**Subject: SWC Rider-Redland's Warehouse Project (DPR #21-00003)
Scoping Agreement and VMT Analysis Review #4, City of Perris**

RK ENGINEERING GROUP, INC. (RK) has reviewed the scoping agreement and VMT analysis #4 for the SWC Rider – Redland's Warehouse Project (DPR #21-00003). The project would include approximately 133,000 square feet of warehouse fulfillment center within the Perris Valley Commerce Center Specific Plan (PVCC SP). The project is located on the southwest corner of Redlands Avenue and Rider Street in the City of Perris. The project will have one access on Rider Street and one access on Redlands Avenue. The scoping agreement was prepared by Webb and Associates and is dated 12/23/2021.

Figure 2: Project Trip Distribution - Trucks

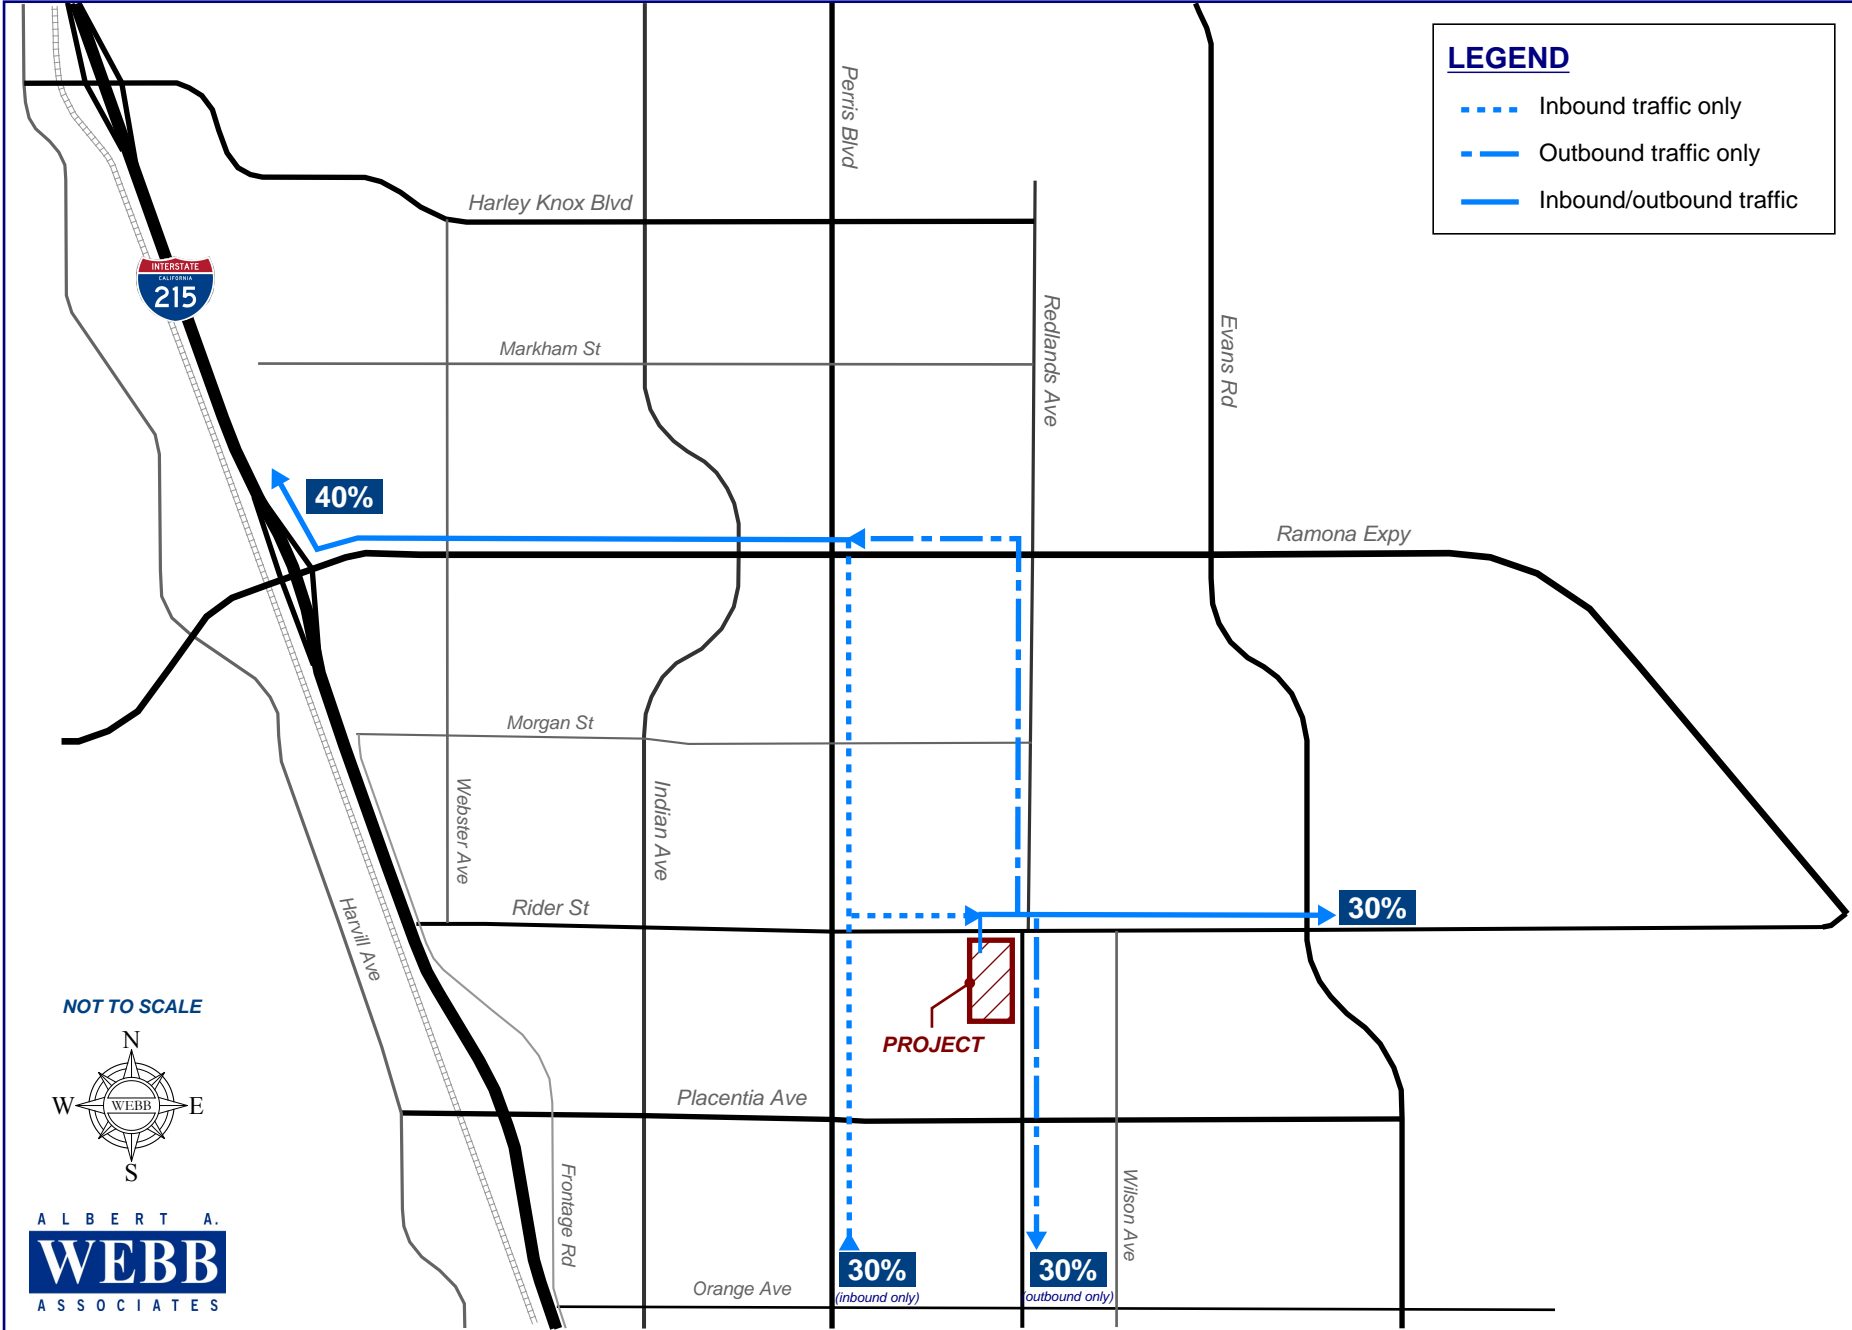
1. The VMT Analysis and Scoping Agreement is acceptable from a technical standpoint.
2. Figure 2, Project Trip Distribution is acceptable for trucks as revised.
